SERVICE BULLETIN

Bulletin No: JC-006-12

Product Type: 61" FastCat Pro

Issue: Constricted purge/vent line could potentially affect fuel system performance

(Enlarged View)

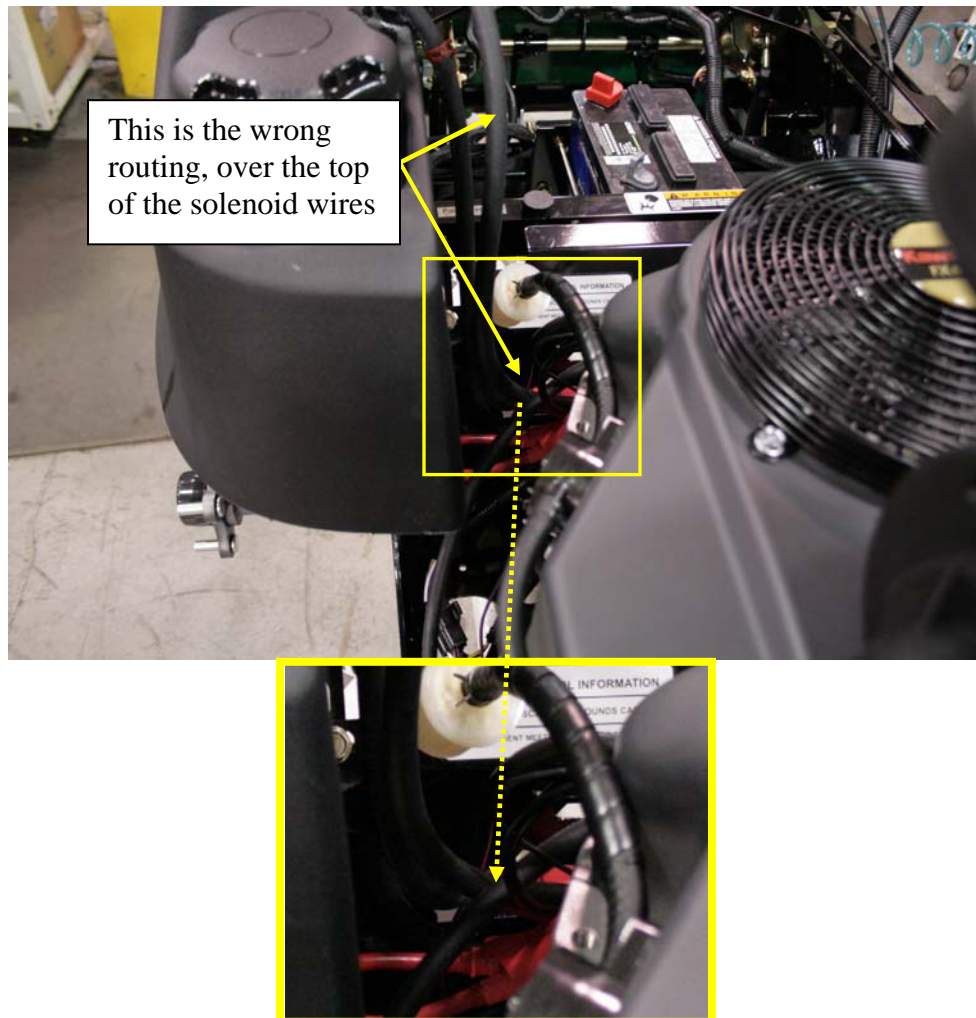
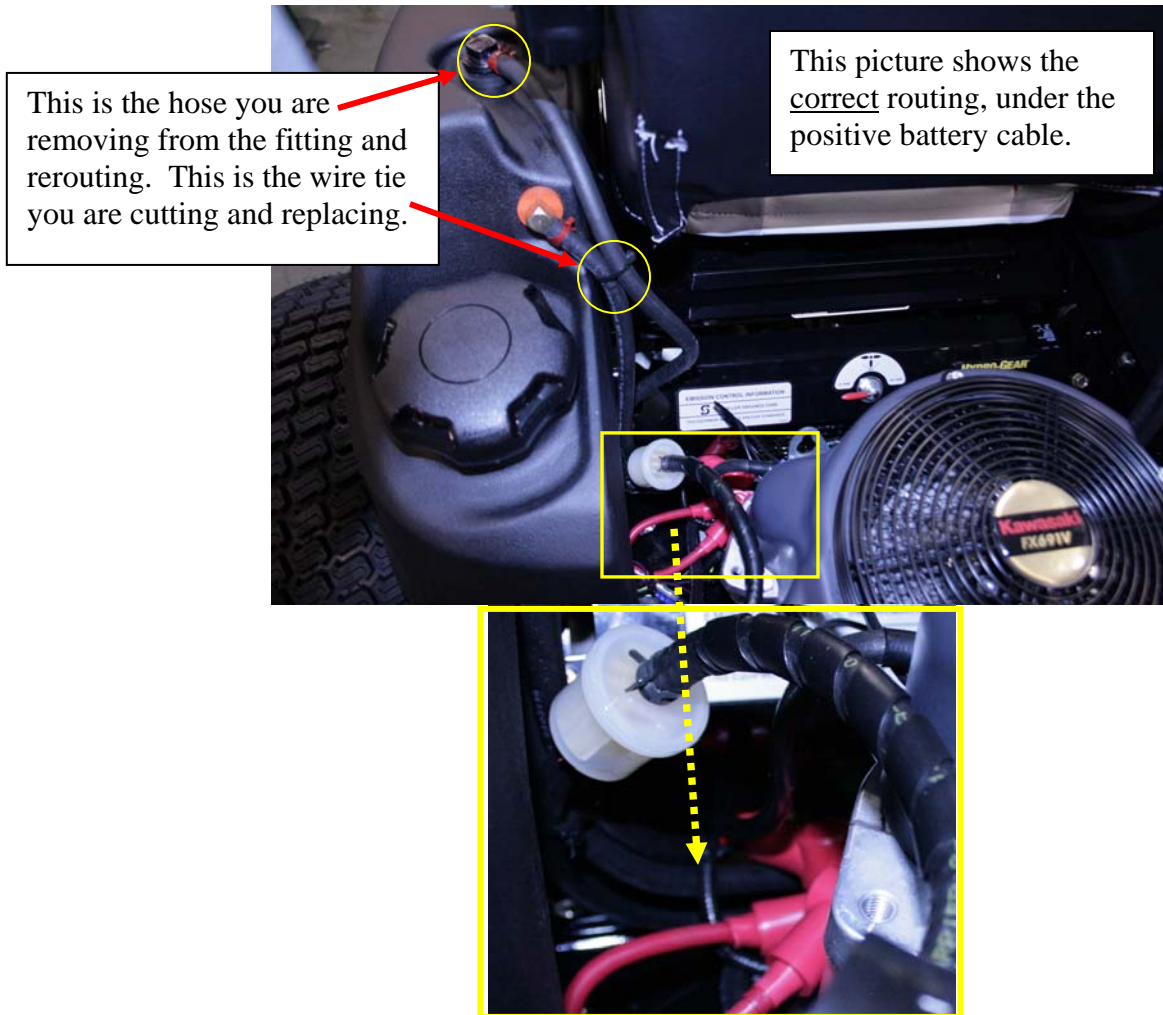
Cause: Incorrect routing leads to kinking of purge/vent line

Action Required: Remove hose from top of left-hand fuel tank and re-route it under positive battery cable, install new wire ties as illustrated below.
